Economic Commission for Europe**Inland Transport Committee****World Forum for Harmonization of Vehicle Regulations****Working Party on Passive Safety****Sixty-third session**

Geneva, 14-18 May 2018

UN Regulation No. 29 (Cabs of commercial vehicles)**Proposal for Supplement 4 to the 03 series of amendments to
UN Regulation No. 29 (Cabs of commercial vehicles)****Submitted by the expert from Germany***

Figure 1

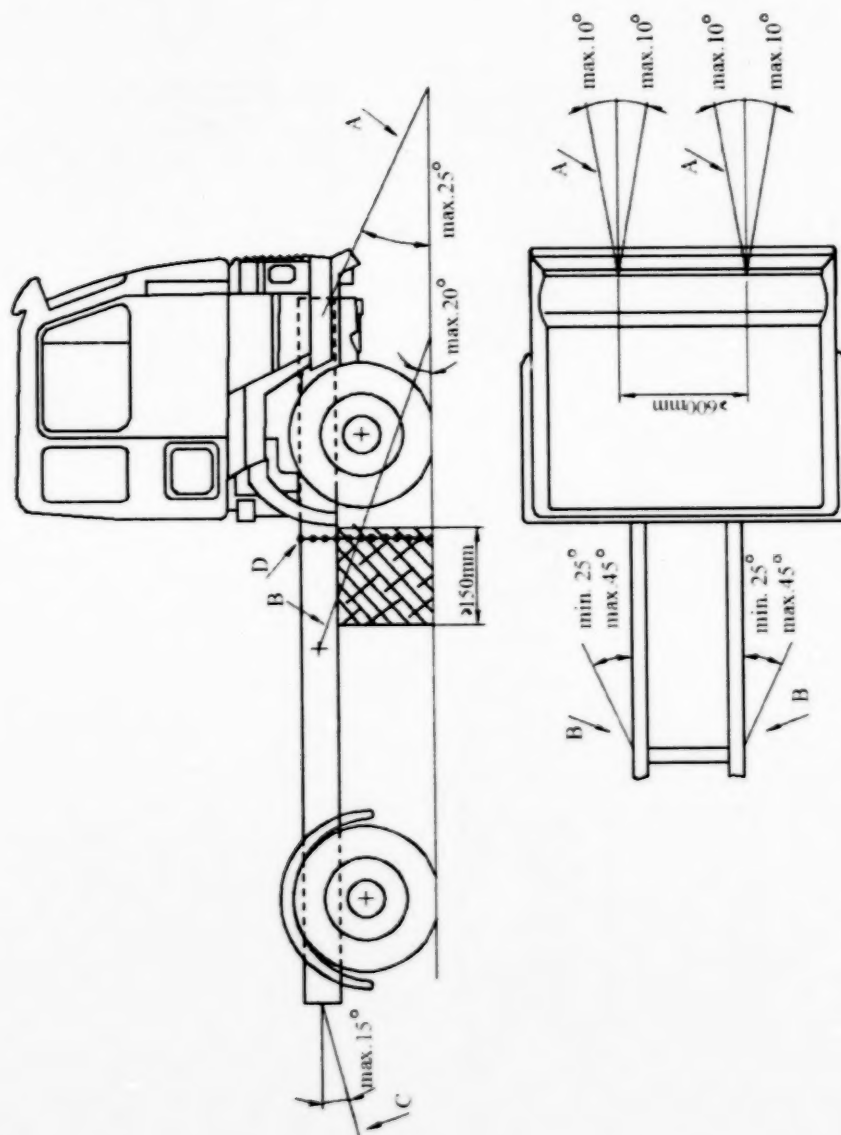
Rearward movement of the chassis frame shall be limited by chains or ropes A attached to the front of the chassis frame symmetrically in relation to its longitudinal axis, the points of attachment being not less than 600 mm apart. The chains or ropes shall when tensioned form a downward angle of not more than 25° with the horizontal and their projection on a horizontal plane shall form an angle of not more than 10° with the longitudinal axis of the vehicle (**see figure 1 below**). The chains or ropes may cross one another.

Lateral movement shall be limited by chains or ropes B attached to the chassis frame symmetrically in relation to its longitudinal axis. The points of attachment to the chassis shall be not more than 5 m and not less than 3 m from the front of the vehicle. The chains or ropes shall when tensioned form a downward angle of not more than 20° with the horizontal and their projection on a horizontal plane shall form an angle of not less than 25° and not more than 45° with the longitudinal axis of the vehicle (**see figure 1 below**).

Figure 1, shall be deleted

Insert new Figures 1 and 2, to read:

Front impact test and front pillars impact test

The cab is mounted on the vehicle

Figure 2
Roof strength test
The cab is mounted on the vehicle

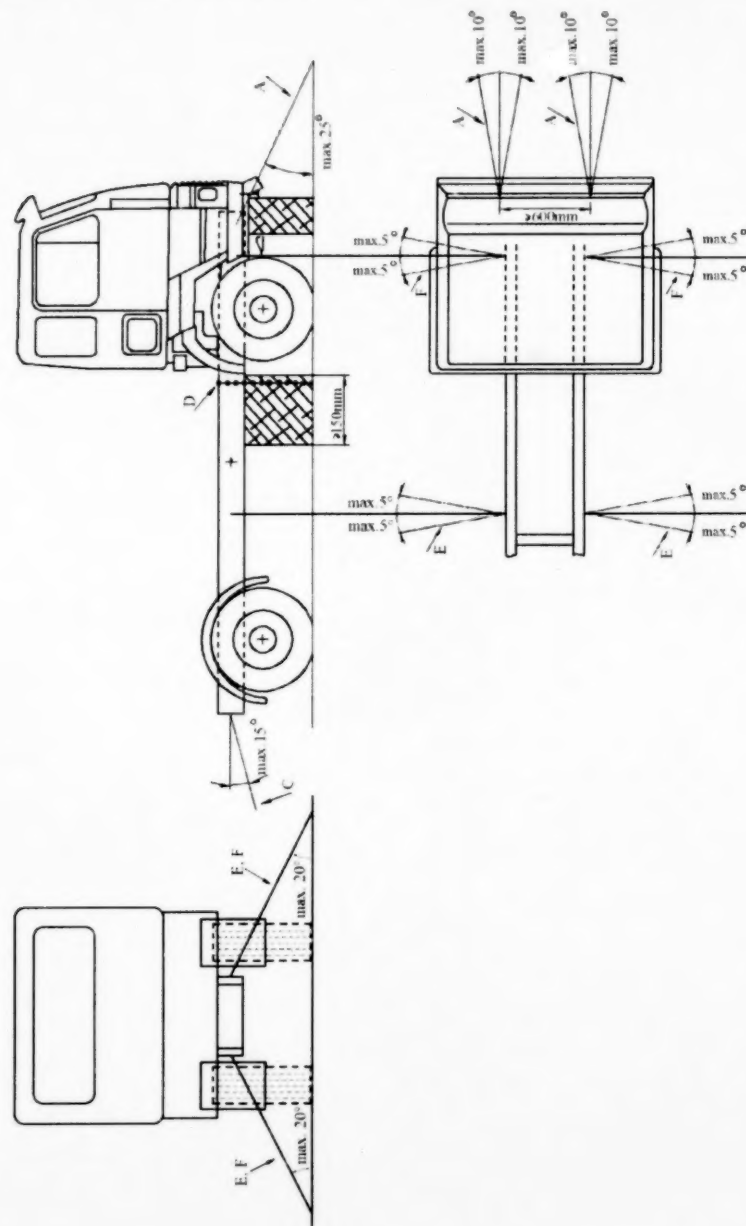
For tests A and B, the chain or rope C shall, to begin with, be placed under a load of approximately 1 kN. All slack in the four chains or ropes A and B shall then be taken up and chain or rope C shall be subjected to a tensile stress of not less than 10 kN. The angle of chain or rope C with the horizontal shall not exceed 15°. A vertical blocking force of not less than 500 N shall be applied at point D between the chassis frame and the ground (**see figure 1 below**). For test C, the chains or ropes B as described above shall be replaced by the chains or ropes E and F (**see figure 2 below**).

The chains or ropes shall when tensioned form a downward angle of not more than 20° with the horizontal and their projection on a horizontal plane shall form an angle $90^\circ \pm 5^\circ$ with the longitudinal axis of the vehicle (see figure 2 below).
